Delegated Report		Analysis sheet	Expiry Date:	29/03/2023
		N/A / attached	Consultation Expiry Date:	23/04/2023
Officer			Application Number(s)	
Miriam Baptist			2023/2881/P	
Application Address			Drawing Numbers	
Units 8-9 Pratt Mews London NW1 0AD			See Decision Notice	
PO 3/4	Area Team Signature	C&UD	Authorised Officer Signature	
Proposal(s)				
Erection of an additional storey to 2 mews buildings.				
Recommendation(s):		Refuse		
Application Type:	Full Planning Permission

*Figure 1: View down Pratt Mews with No 8 at the end. Building to the left, 1-6 Regent House
(Source Google street view)*

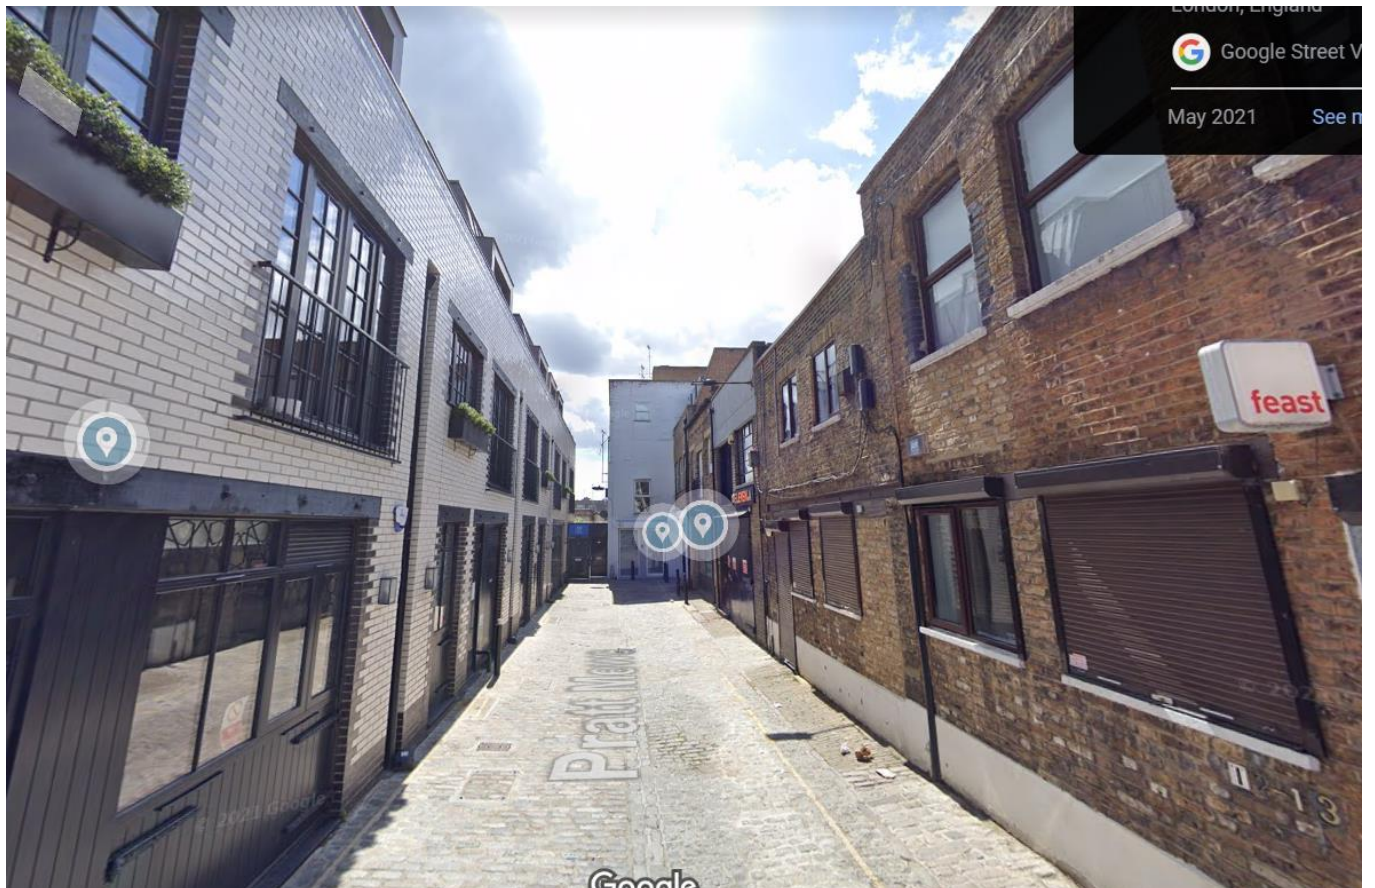
- 3.13 It is noted that the building opposite the application site, 1-6 Regent House, is fairly new (ref 2013/7739/P) and has been built with respect to the mews typology, at 2 storeys plus a set-back mansard level (see figure 1 below). Such development is considered to successfully protect the humble scale of the mews typology.
